RE: **Contract No. NB-630-000-006**
Administration Building Additions and Rnovations
Nice Bridge

ADDENDUM NO. 3

TITLE: Administration Building Addition and Renovation

FACILITY: Nice Bridge

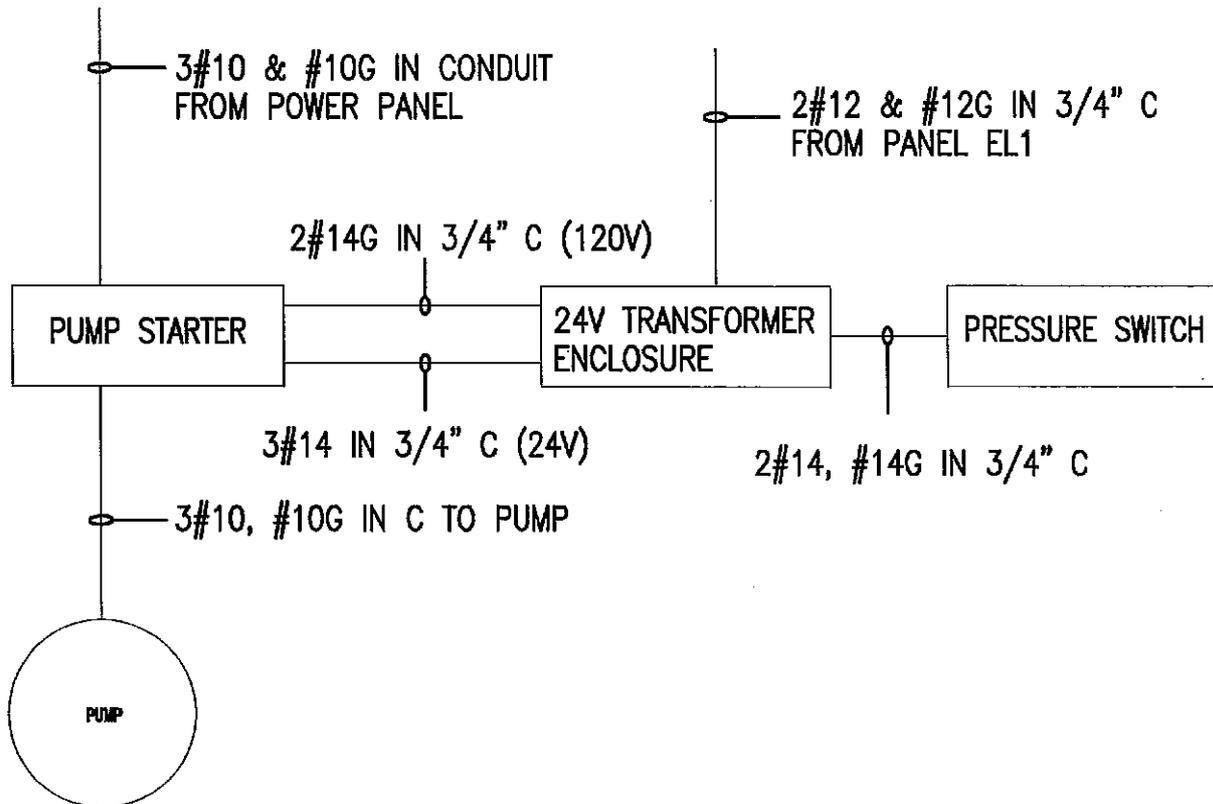
31. Provide all control wiring as per Sketch 15, 16, & 17 for submersible pump. Wiring inside the building shall be in EMT and use spare duct per note 6 on drawing E-7 for outside control wiring.

NICE BRIDGE ADMINISTRATION BUILDING HVAC PROJECT
 ADDENDUM - I; DRAWING M-2; SKETCH-1

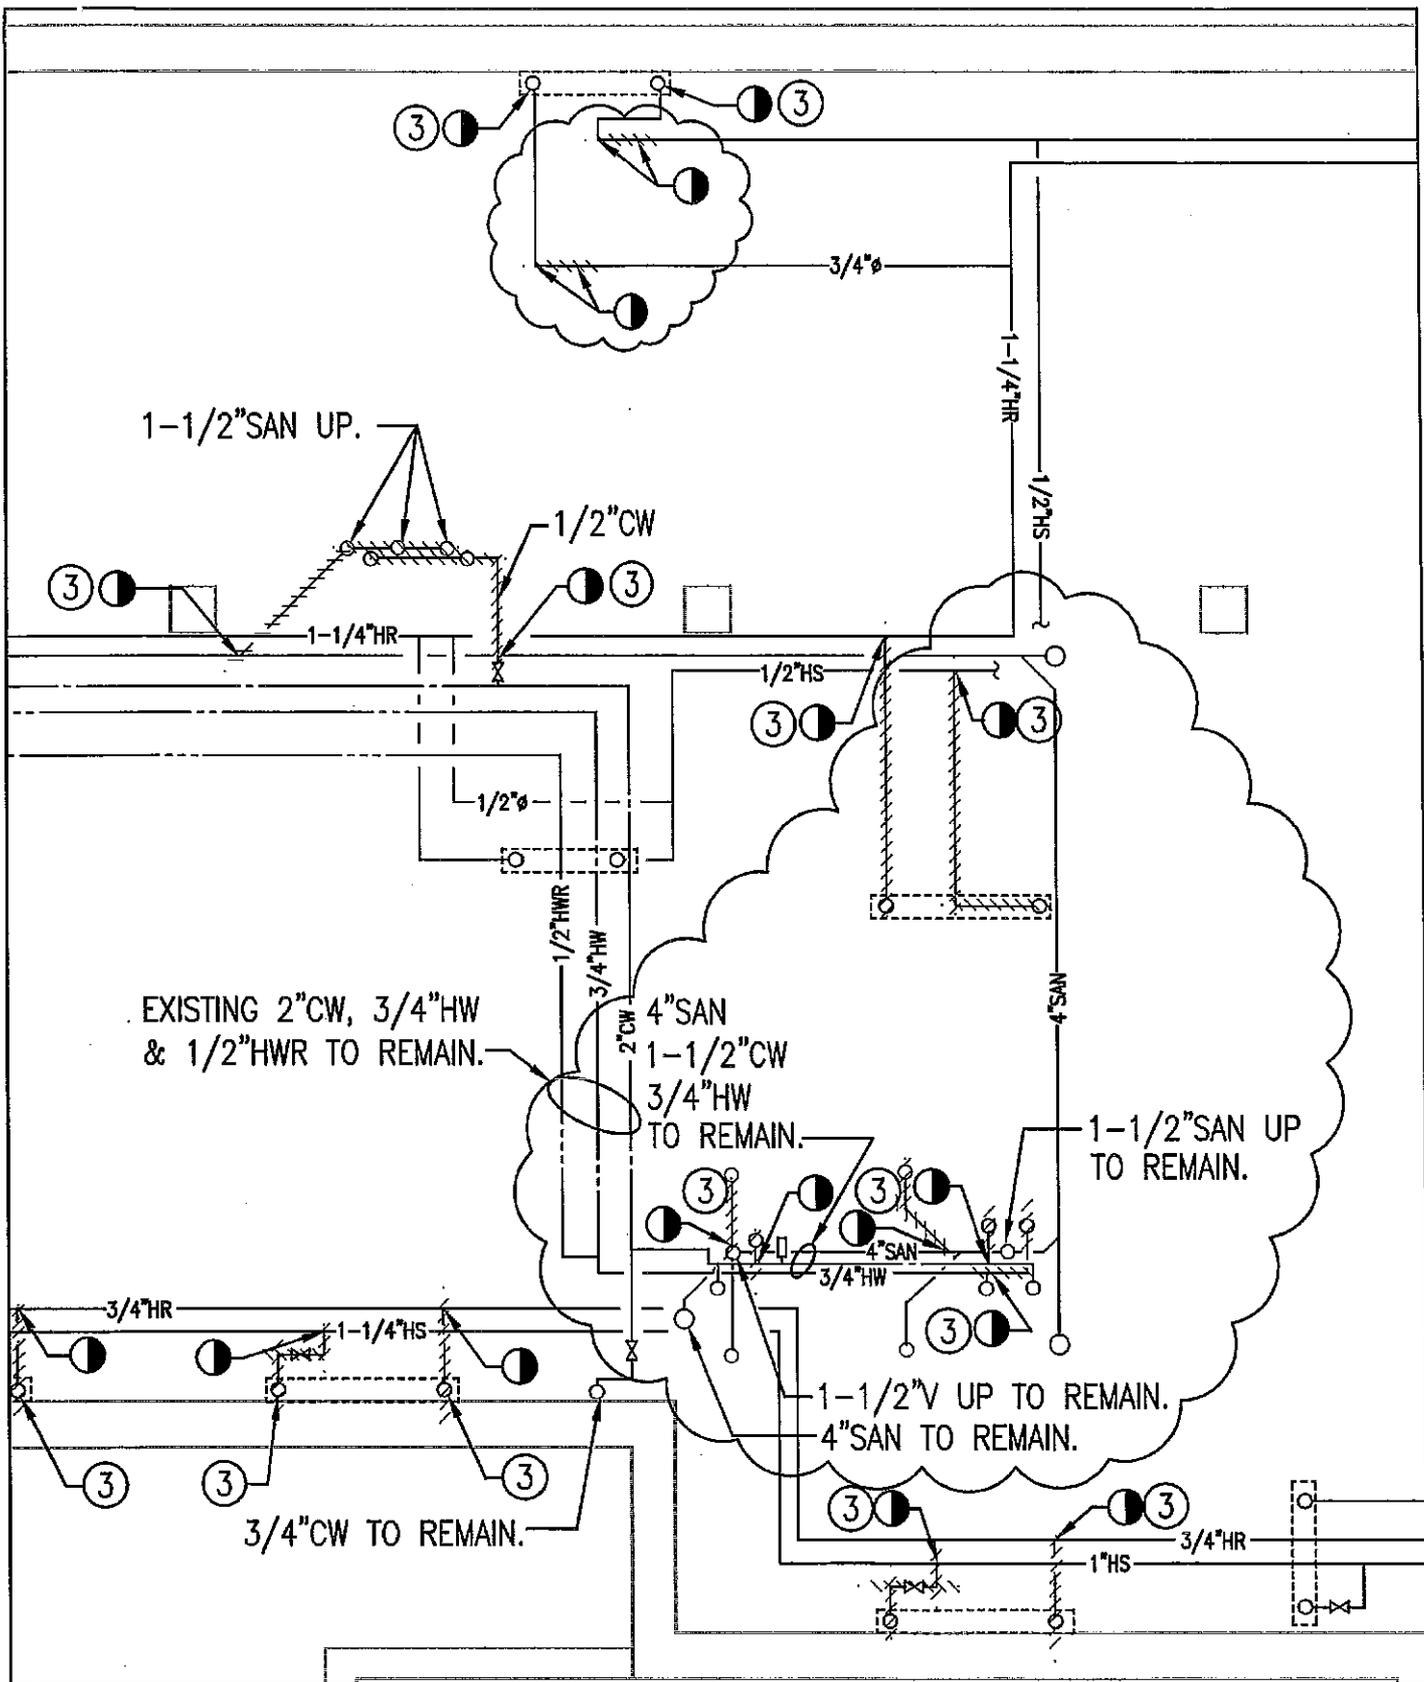
6. Remove a portion of ¾” HS, ¾” HR serving connector upstairs, to accommodate new piping as indicated on attached M-2, sketch 1.

NICE BRIDGE ADMINISTRATION BUILDING HVAC PROJECT
 ADDENDUM - I; DRAWING M-3; SCHETCH-2

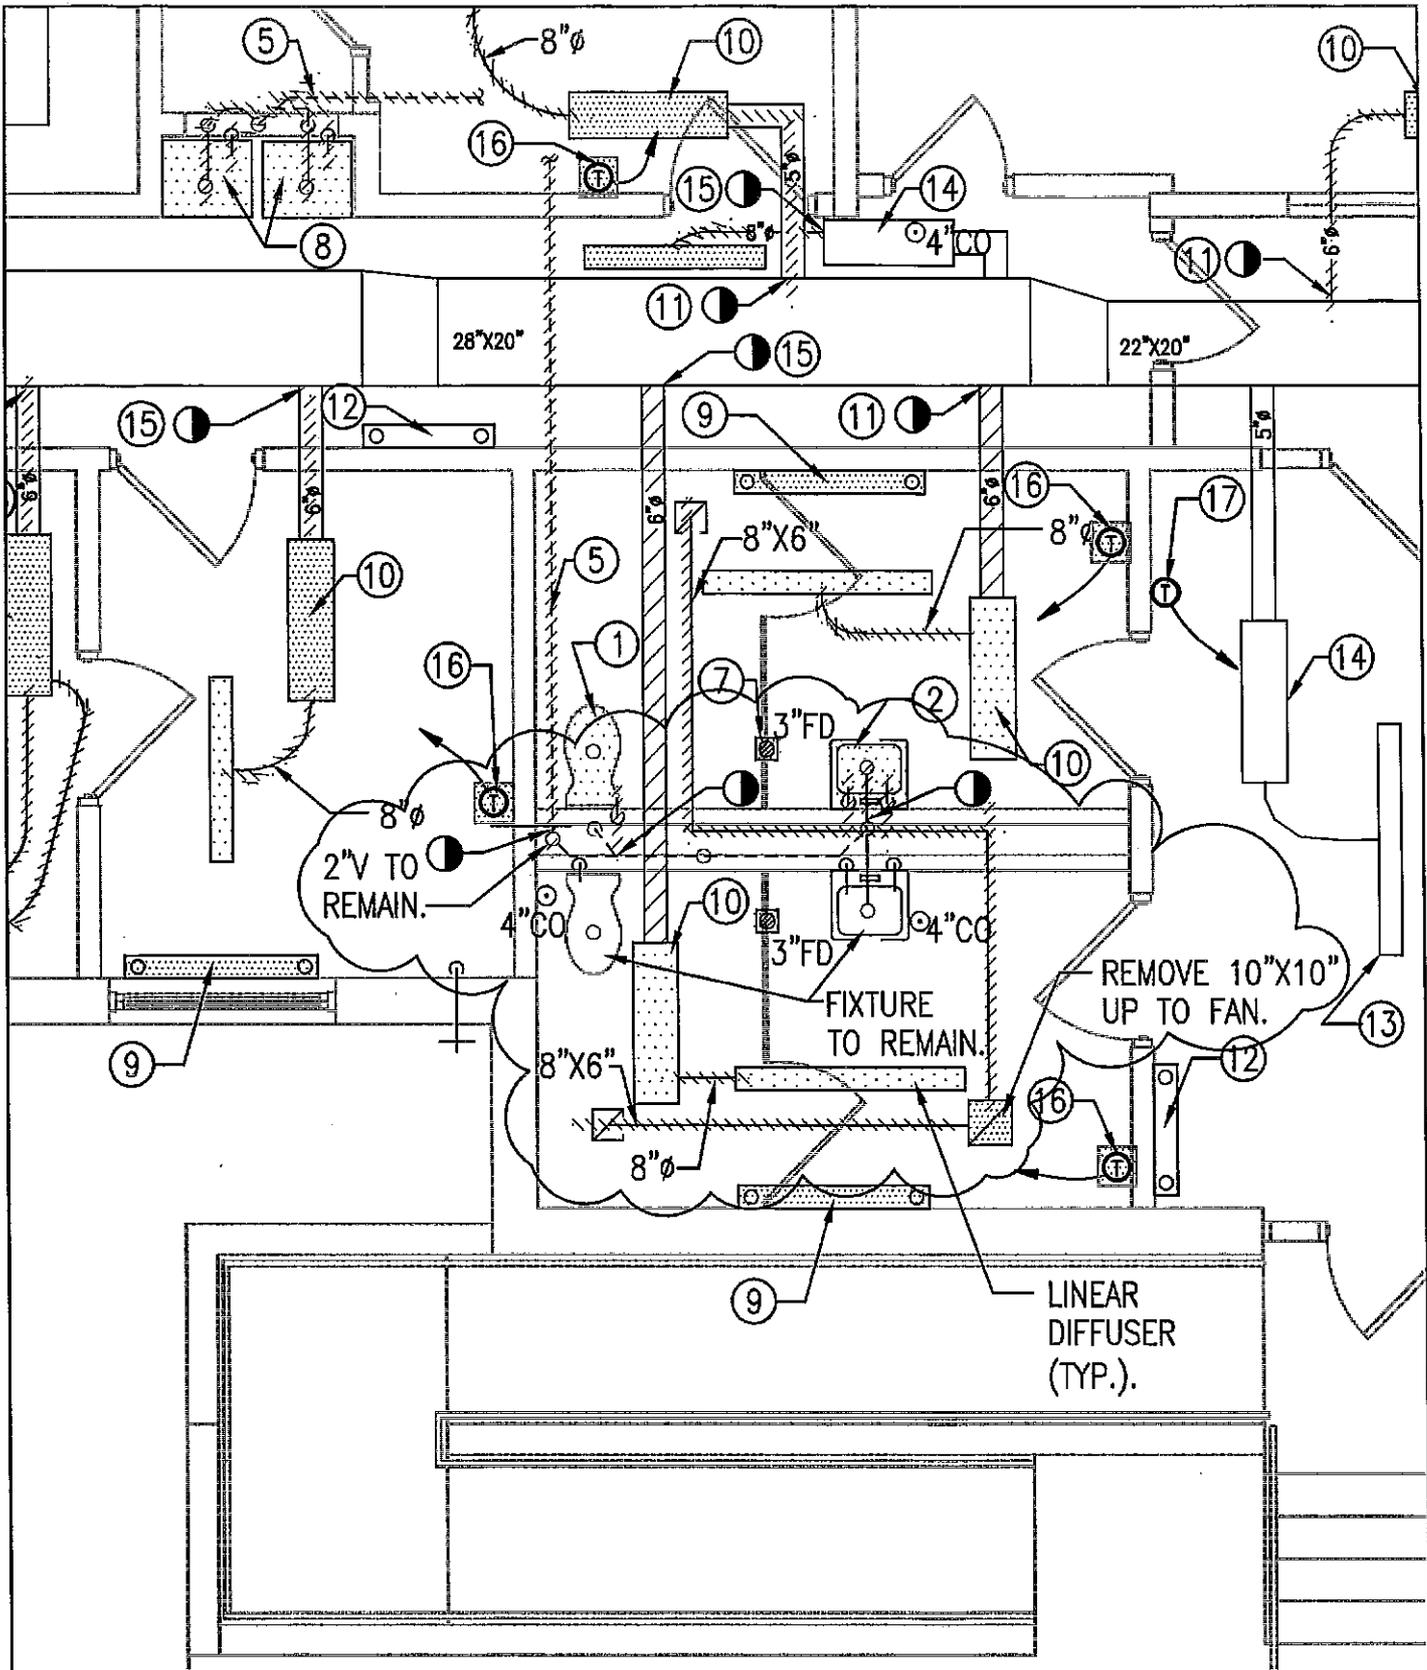
1. Revise First Floor Demolition Plan to retain fixtures and services for toilet 119 directly adjacent to police south entrance as indicated on attached M-3 sketch.
2. Remove exhaust duct up to existing fan serving toilets 118 and 119 as indicated on attached M-3, sketch 2.

<p>NICE BRIDGE ADMINISTRATION BUILDING HVAC PROJECT ADDENDUM - I; DRAWING M-4; SKETCH-3</p>	<p>MAY 15, 2009</p>
--	---------------------

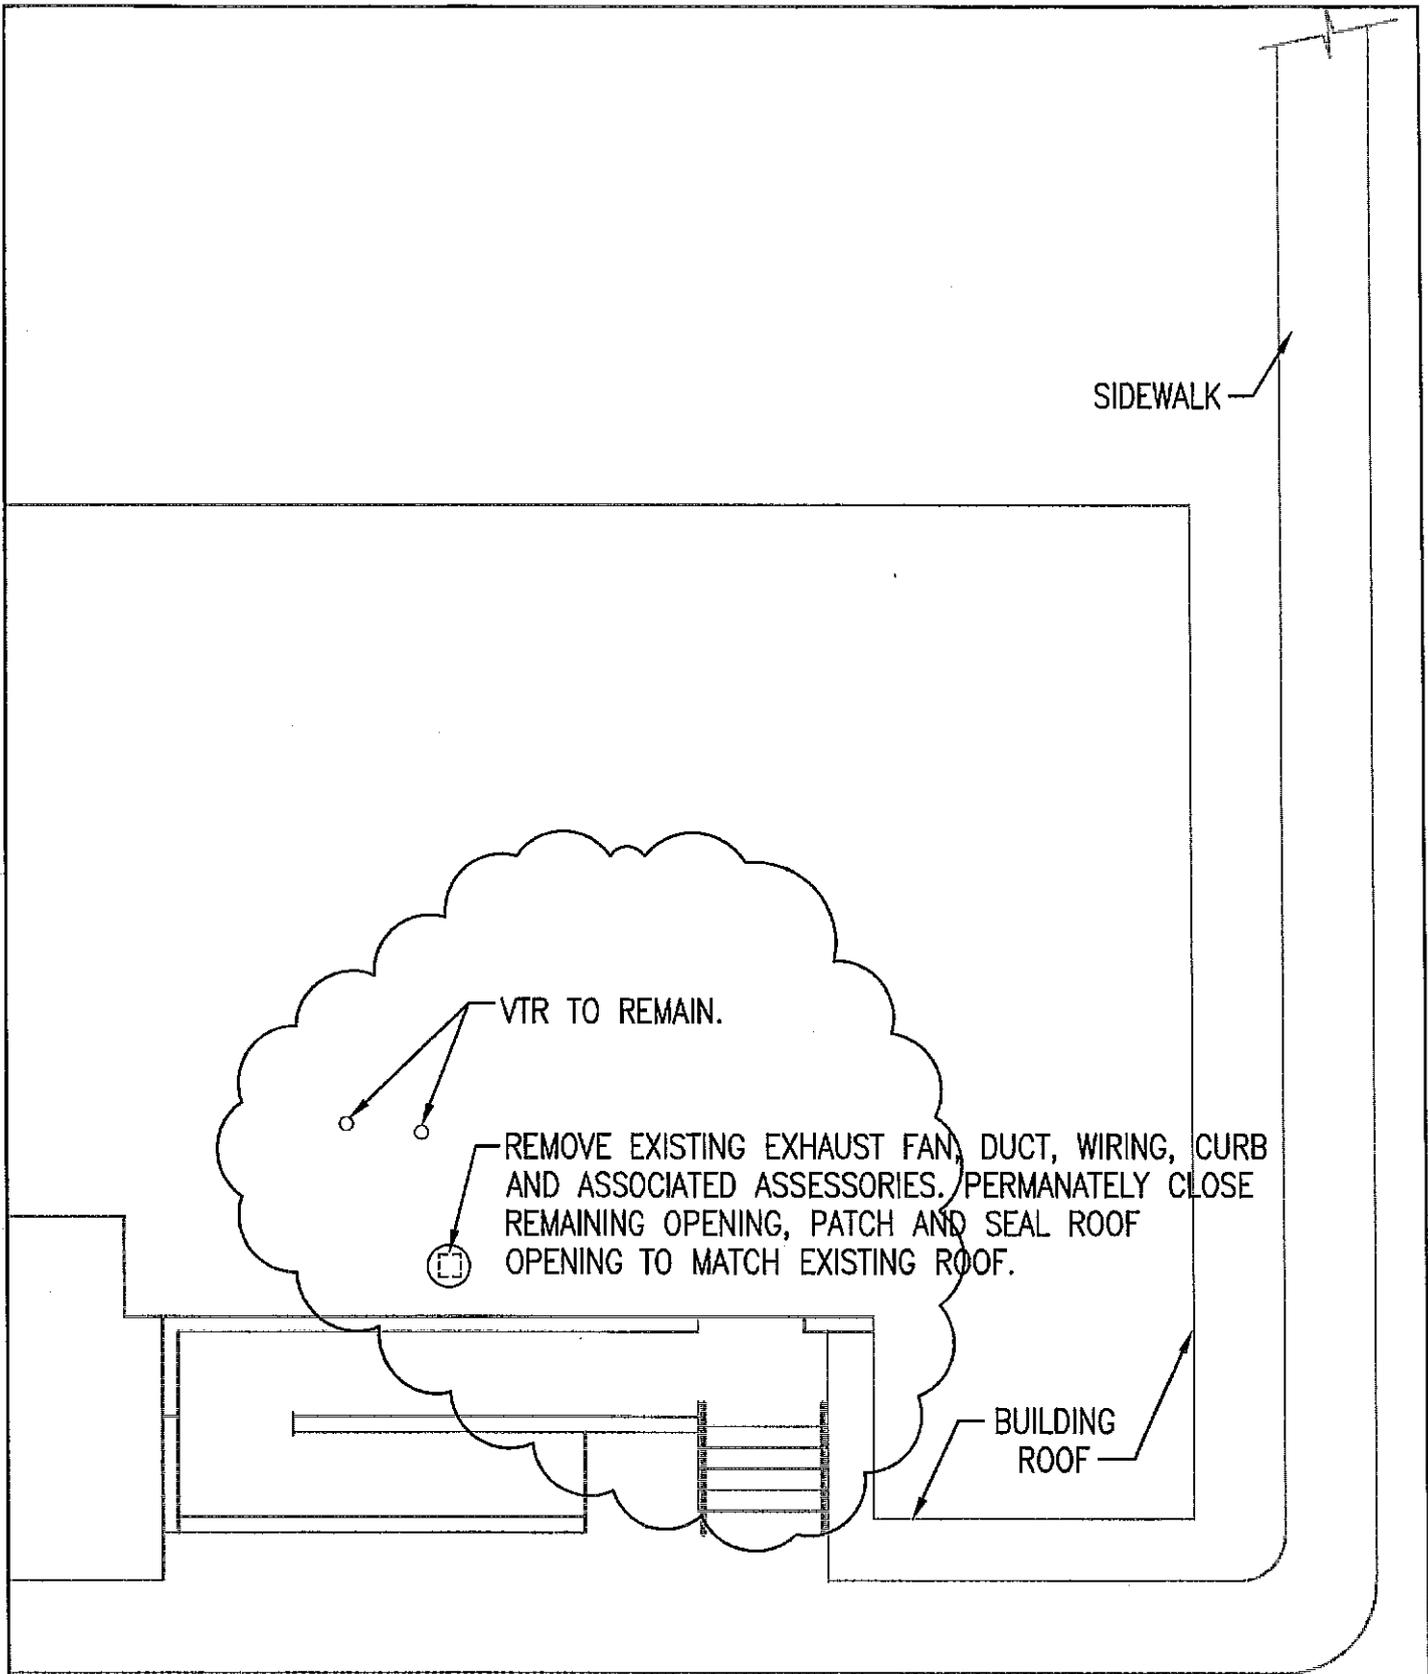
1. Revise 1-1/4” RL on Refrigerant Pipe note on plan to read as – 7/8” RL.
2. Revise Roof Demolition Plan to retain toilet vents and demolish existing exhaust fan as indicated on attached M-4, sketch 3.

NICE BRIDGE ADMINISTRATION BUILDING HVAC PROJECT
 ADDENDUM - I; DRAWING M-5; SKETCH-5

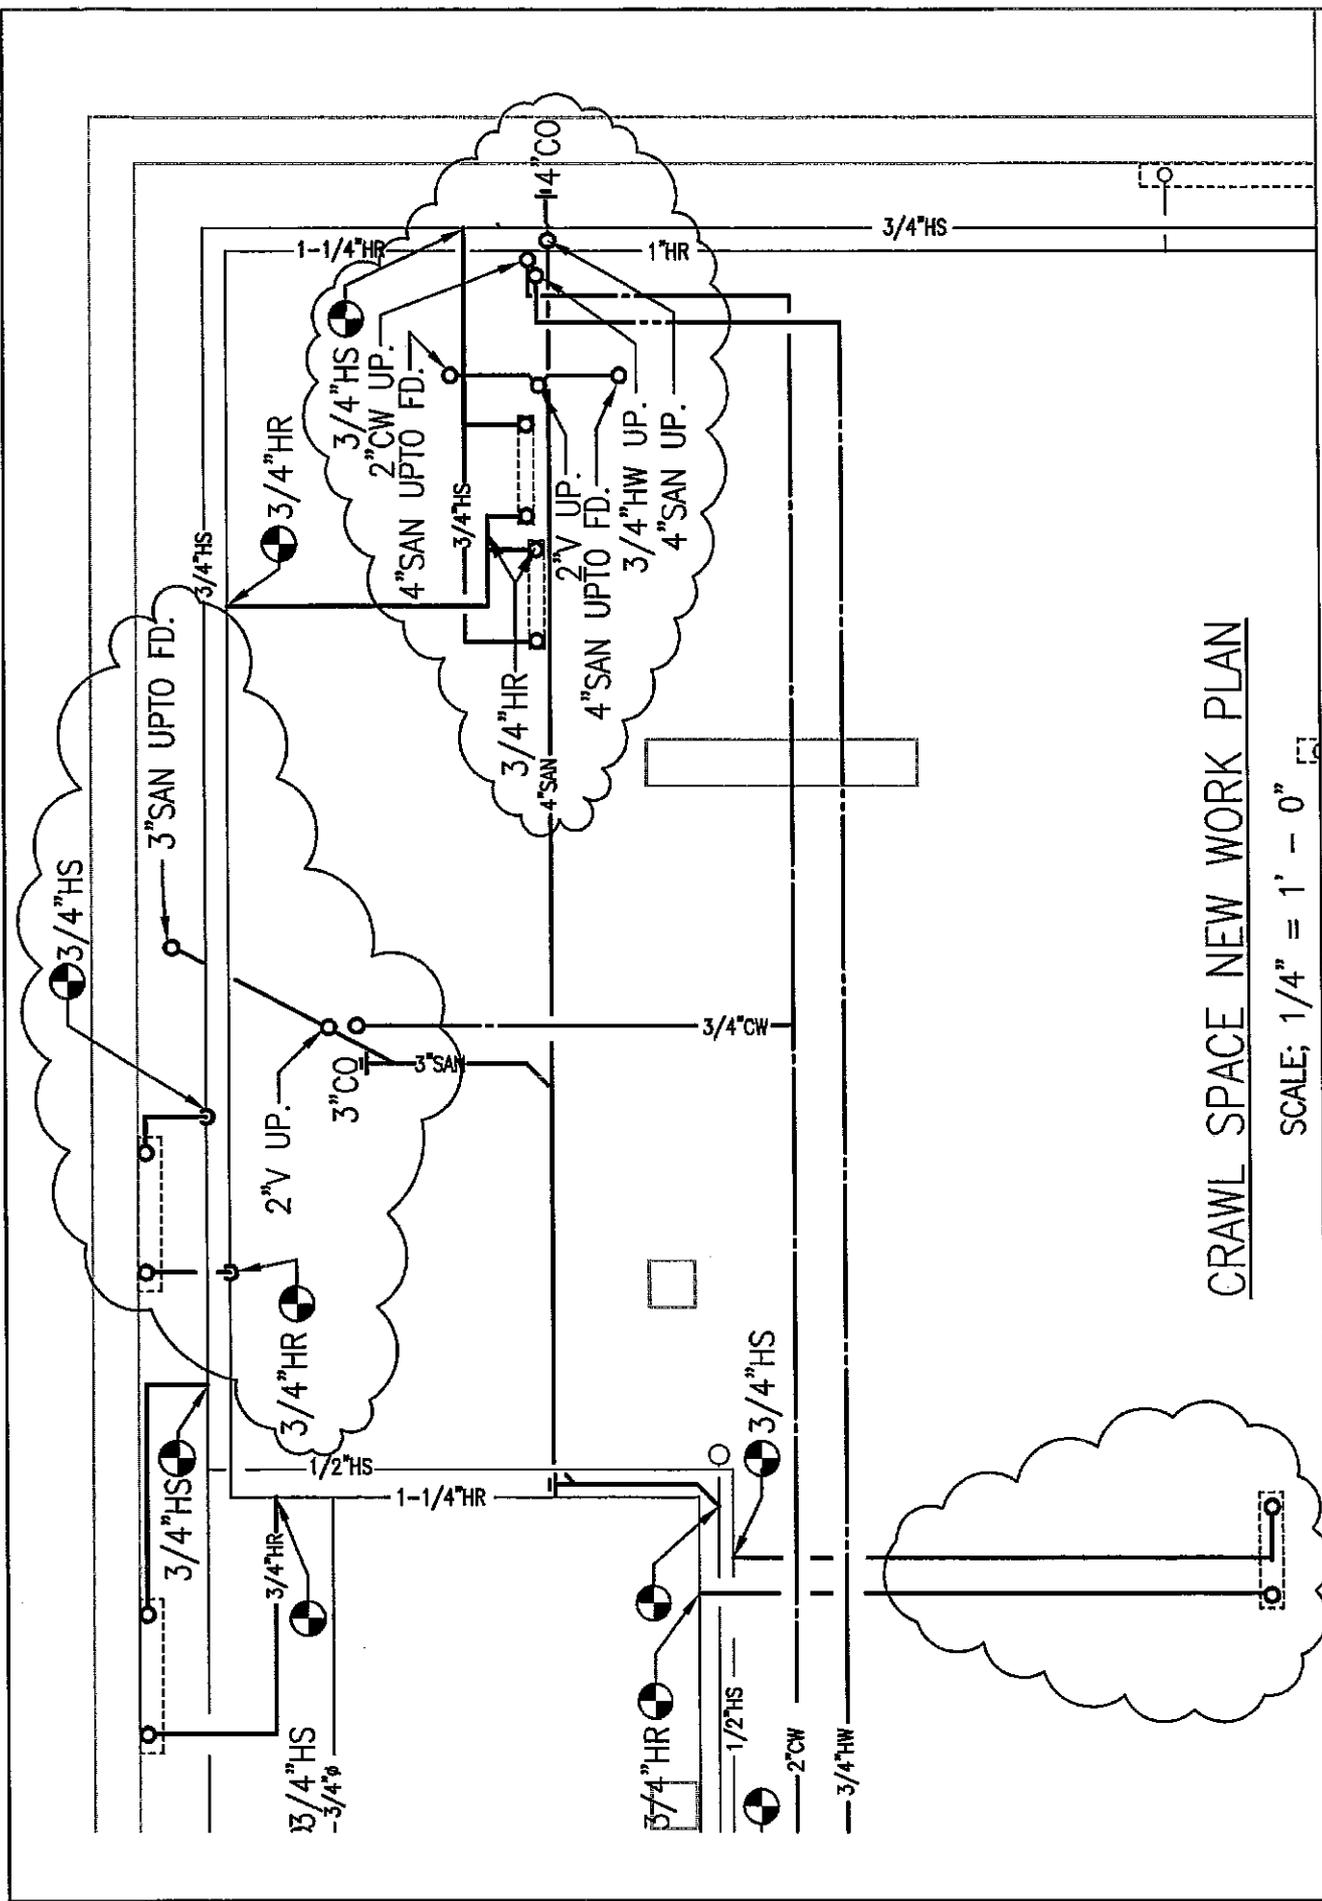
1. Revise Boiler Room Piping Plan as indicated on attached M-5, sketch 4.
2. Add Heating Hot Water Piping to convector above, as indicated in attached M-5, sketch 5.
3. Revise Note 12 to read as-
“Provide New Refrigerant piping between existing chiller and new air cooled
